STAFF REPORT FOR THE PLANNING COMMISSION

FILE NUMBER: CUP-12-01/DR-12-03

REQUEST: Conditional Use and Class II Design Review approval for construction of a pump station at the Bland Reservoir site at 23120 Bland Circle

CITY OF WEST LINN
 BLAND CIRCLE INTERTIE
 WATER PUMP STATION
 PROPOSED SITE PLAN

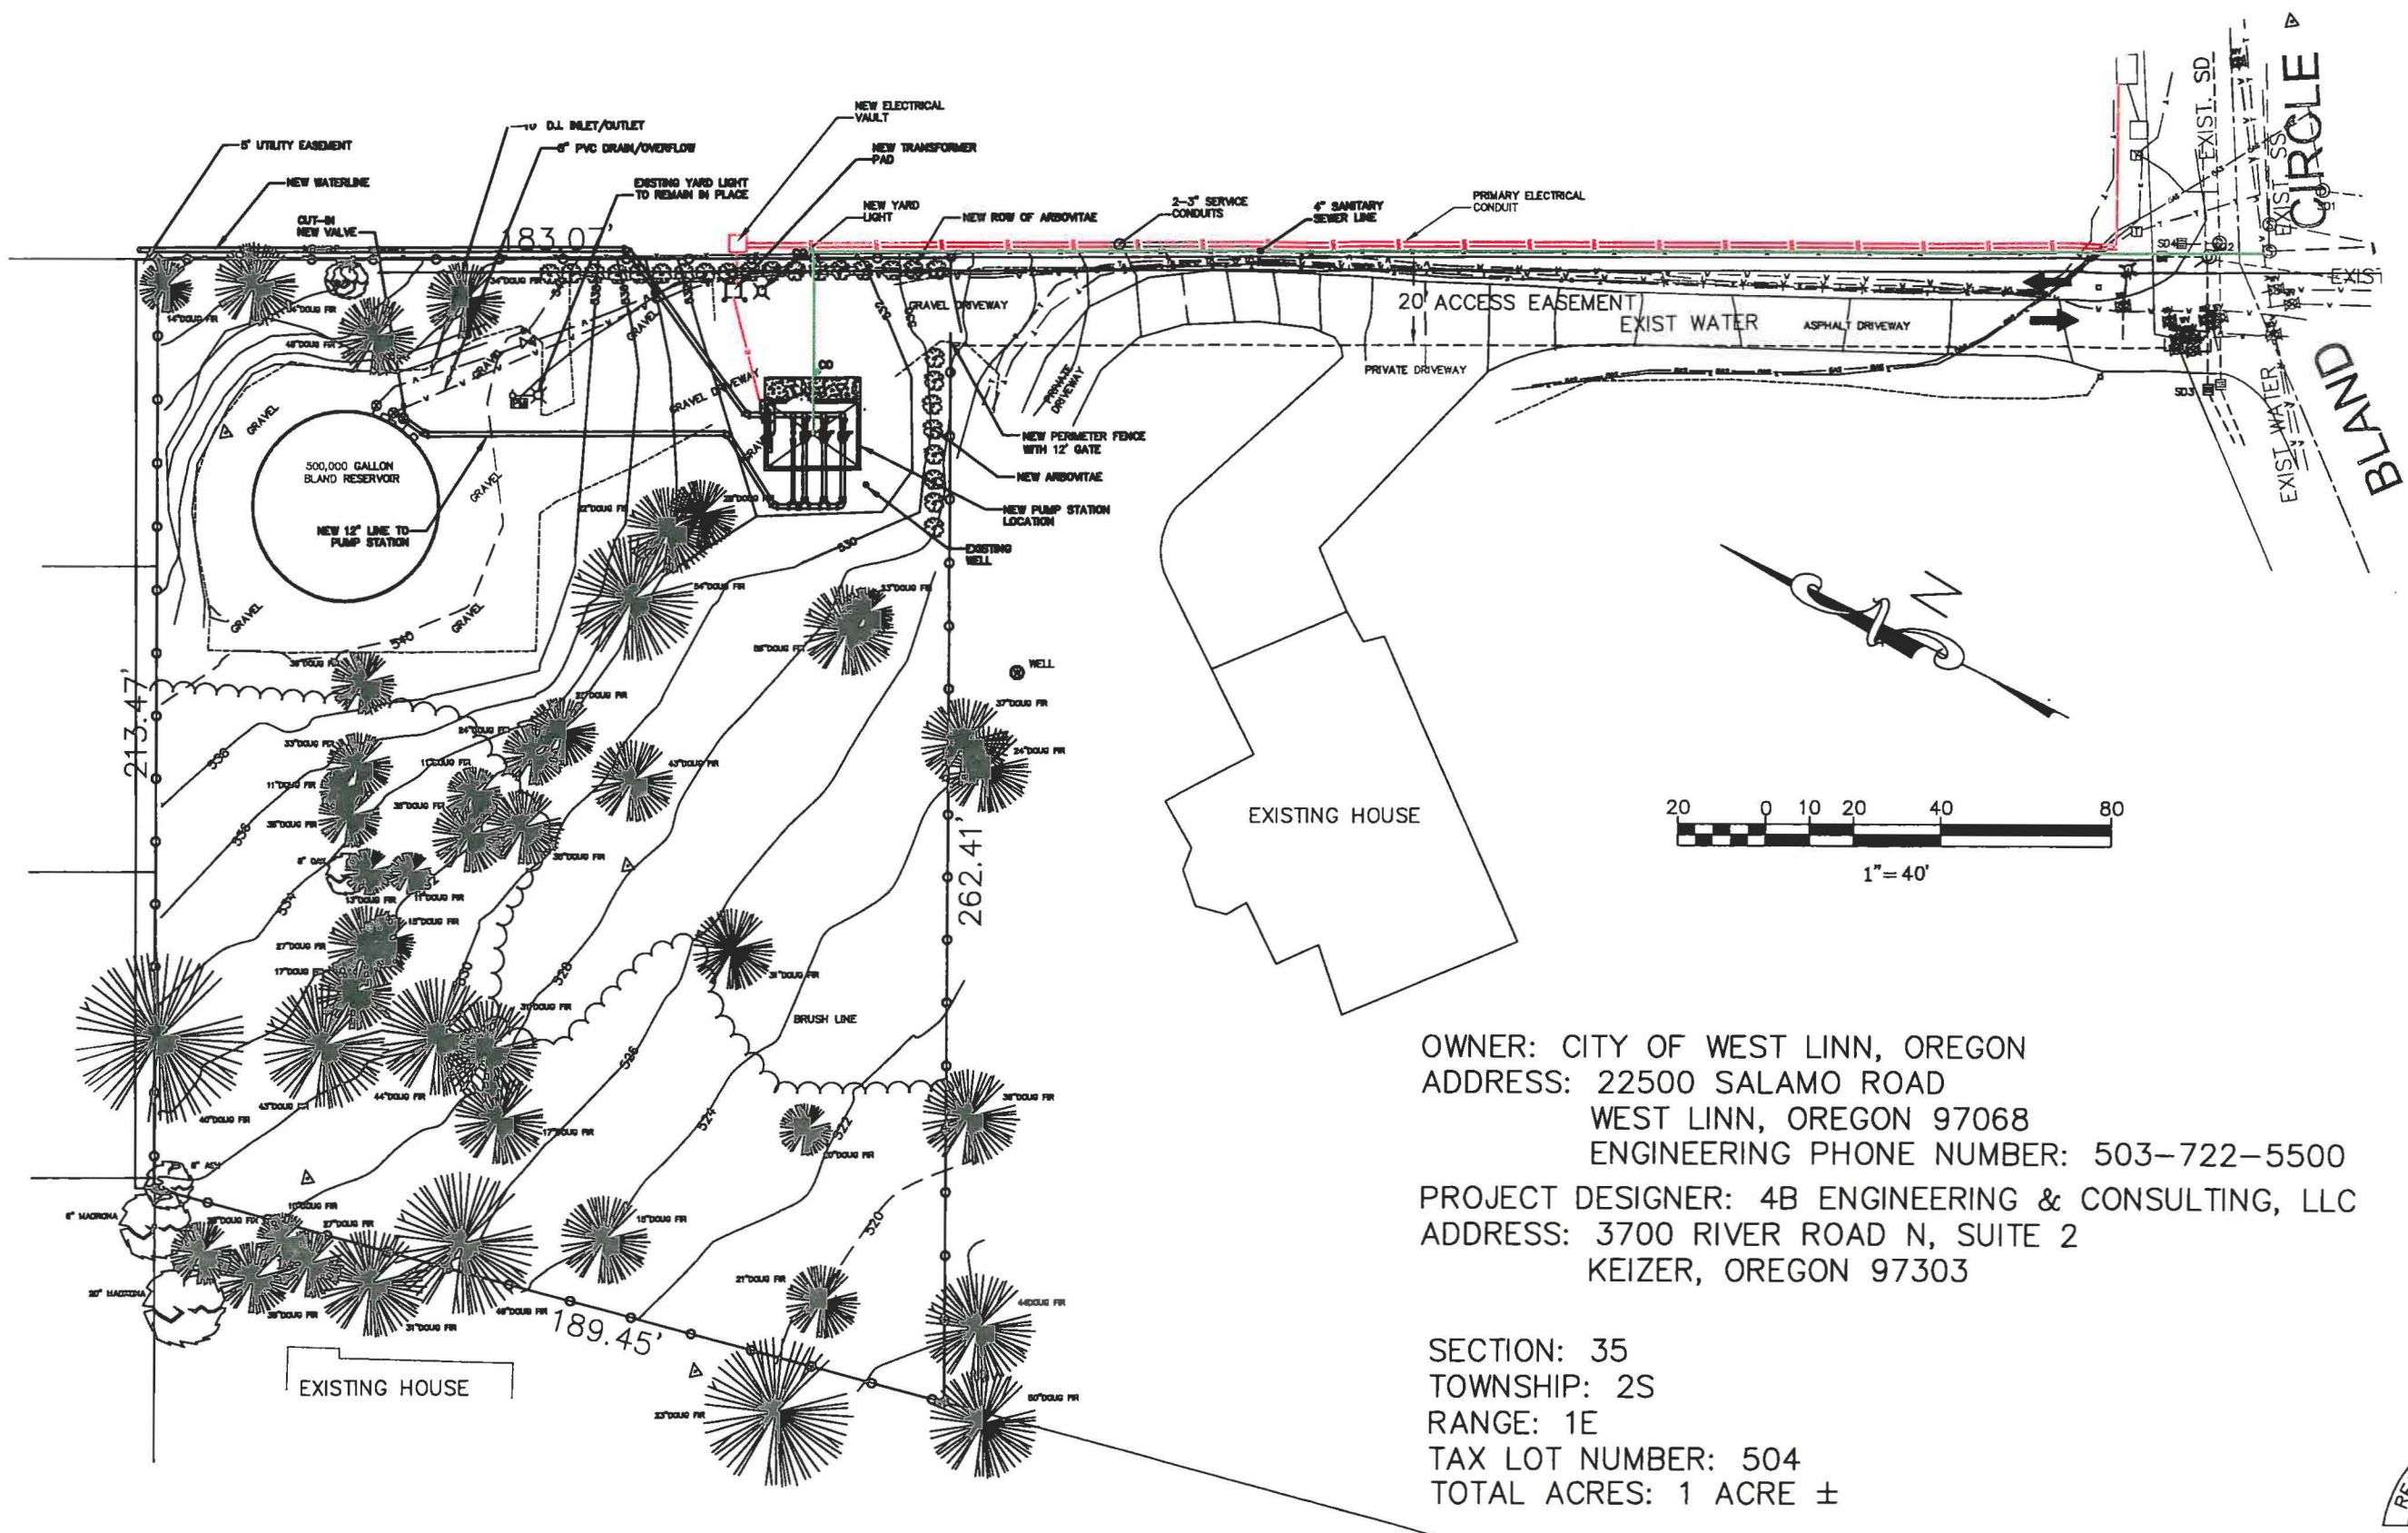
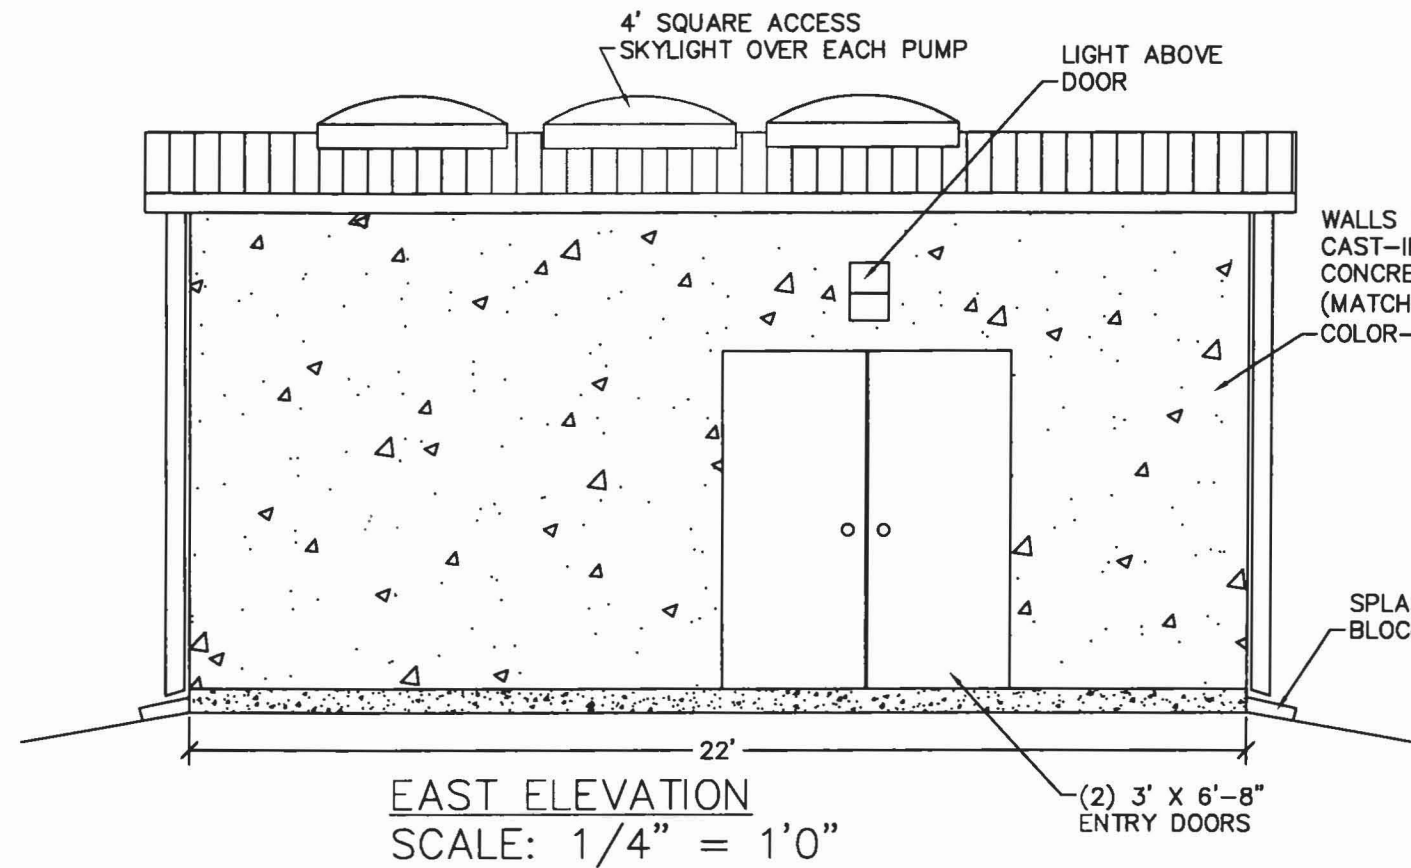
residences (see Exhibit PC-3, Proposed Site Plan, sheet 6, page 114). Proposed Condition of Approval 6 calls for the fence to be located behind the proposed arborvitae.

The pump station equipment is proposed to be located in an approximately 14.5-foot-tall, 16-foot by 22-foot building. This building is proposed to be located in the southeast area of the site along the west side of the existing gravel driveway (see Exhibit PC-3, Proposed Site Plan, page 113). The equipment in the building would include three variable frequency drive pumps operating at up to 1800 gallons per minute. There would be a power outlet provided for a backup generator that can be brought on site in case of power failure. Since the backup generator is a portable device that is not built into the site and which would only be brought on site and used during emergencies, the noise it may produce is incidental, infrequent, and not regulated by the CDC. It would need to meet Municipal Code regulations for noise only. The applicant proposes to screen the proposed structure with Arbovitae (see Exhibit PC-3, Landscaping Plan, page 119). A new 6-foot tall fence would separate the site from the adjoining residence to the south (see Exhibit PC-3, Proposed Site Plan, Sheet 6, page 113).

A 6-foot-tall fence is proposed to surround the site as a utility security fence. The gate is proposed on the site plans (see pages 113-114 of Exhibit PC-3) to be 12 feet tall. Proposed Condition of Approval 3 requires the gate to be 8 feet tall or less to comply with this criterion.

On the proposed site plan it looks like the green and red lines for the sanitary sewer and electrical are actually east of the property line and the 20 foot access/utility easement through the neighboring property. Were they meant to be shown within the property line and easement? If not, is there a reason they need to be on the next property to the east and are there plans to acquire an easement on that property for these?

SOUTH ELEVATION
SCALE: 1/4" = 1'0"

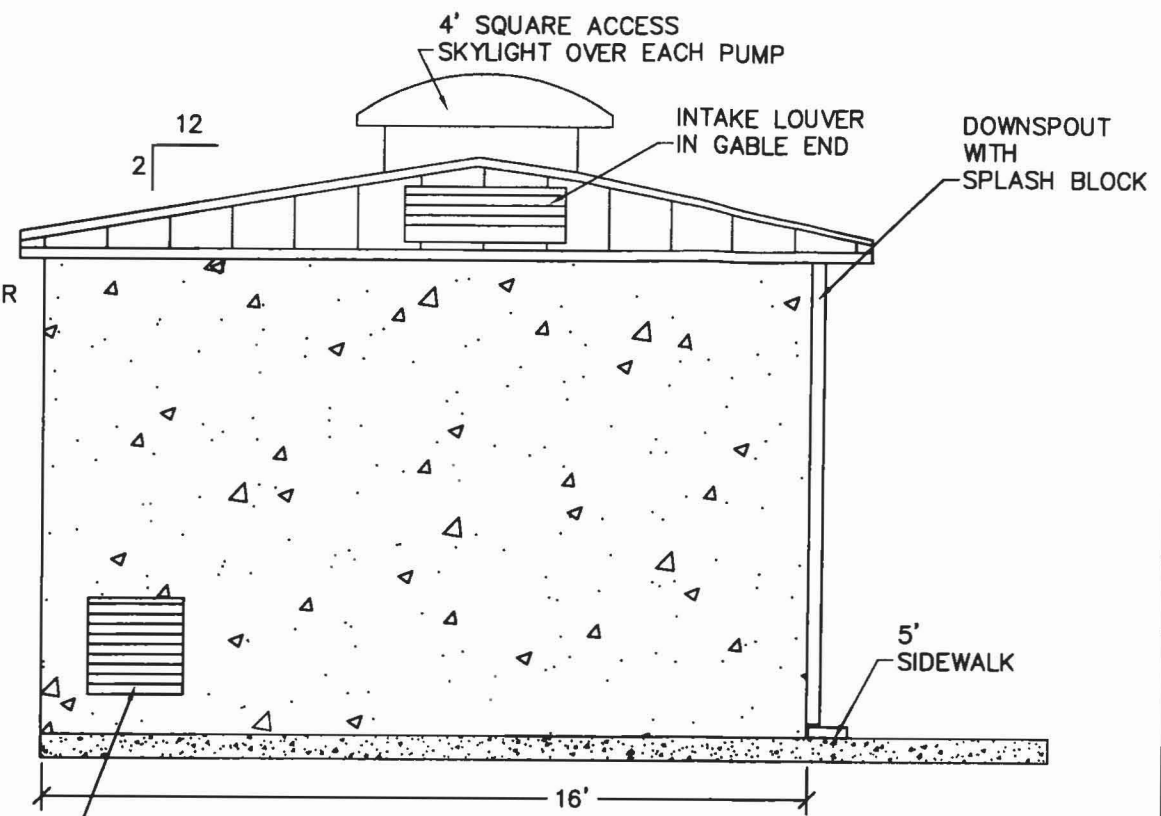
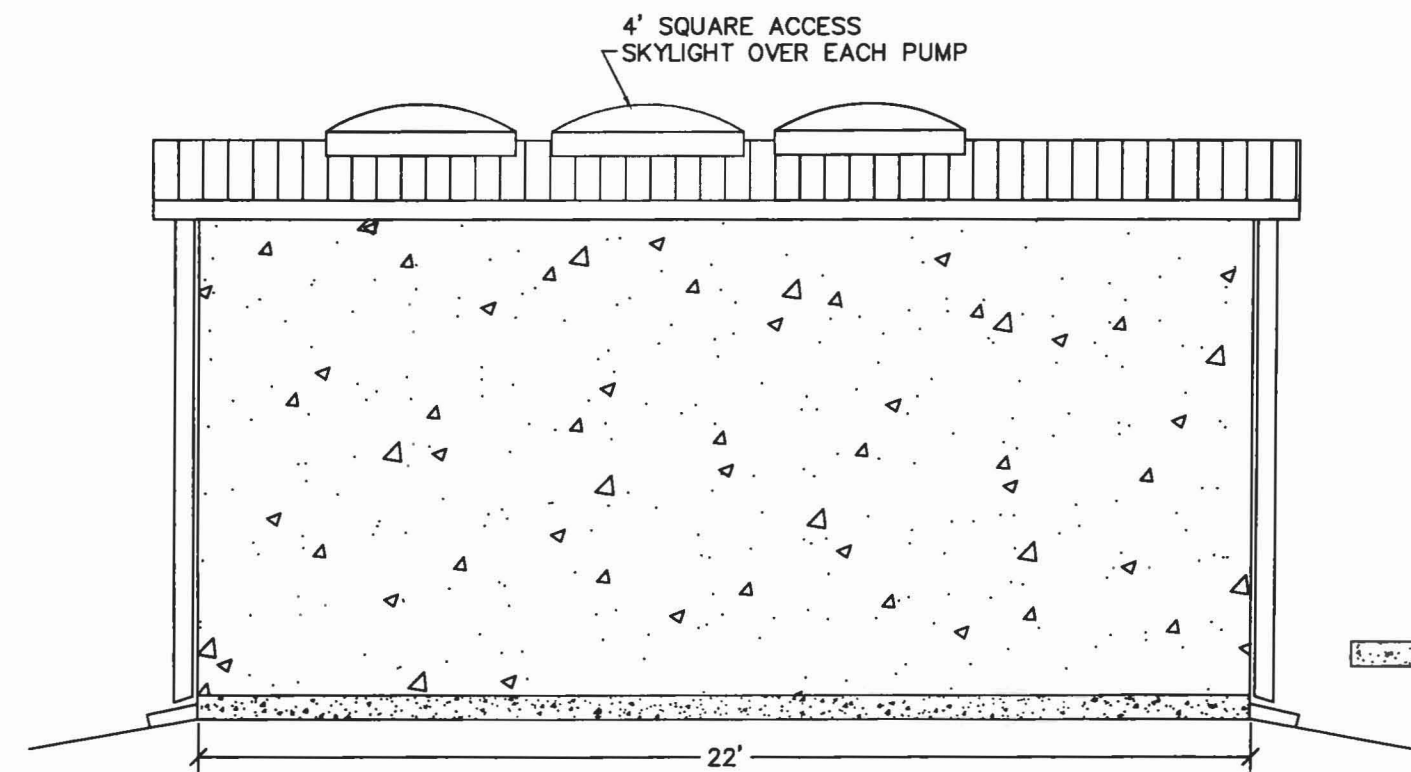
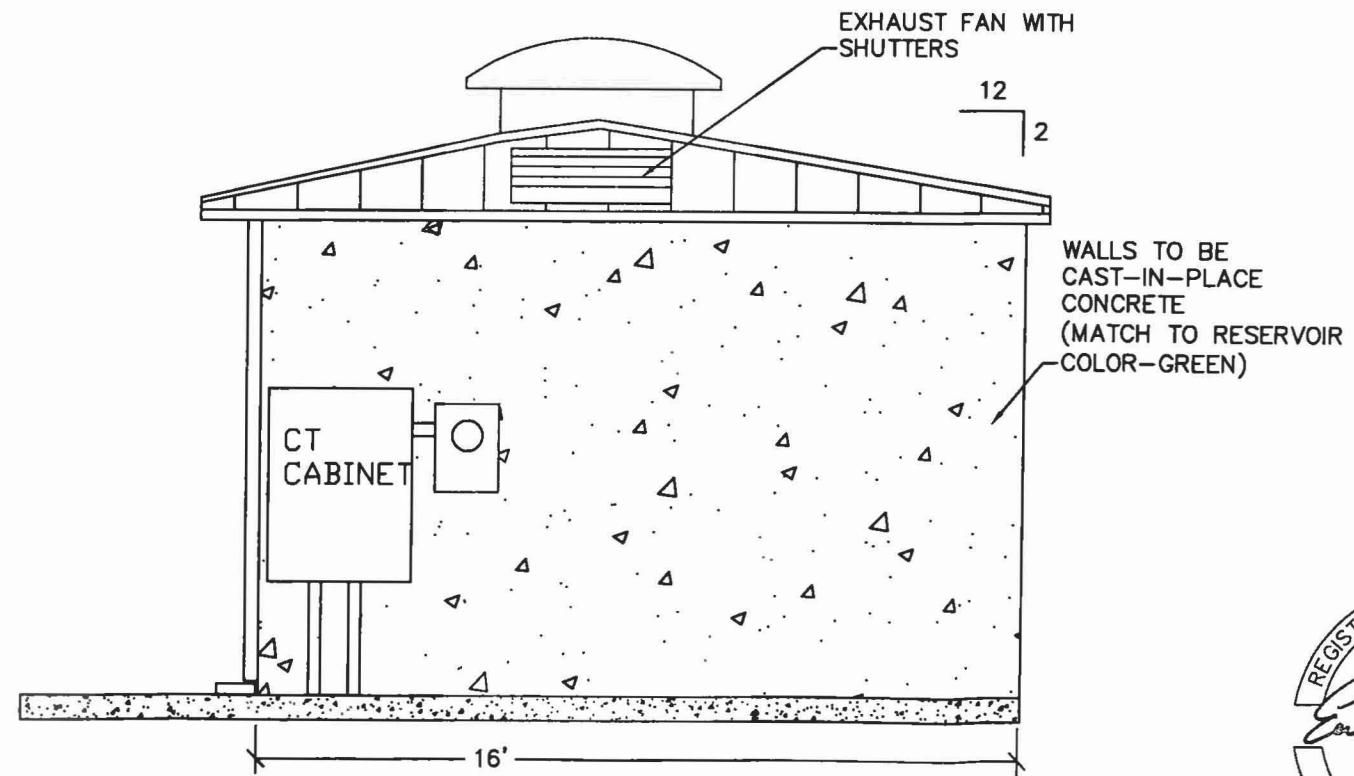
1. Site Plan. With the exception of modifications required by these conditions, the project shall conform to the Proposed Site Plans dated January 25, 2012 located on Page 113 (close-up) and Page 114 (entire site) of Exhibit PC-3, and to the Building Elevations plan dated January 25, 2012 on Page 115 of Exhibit PC-3.
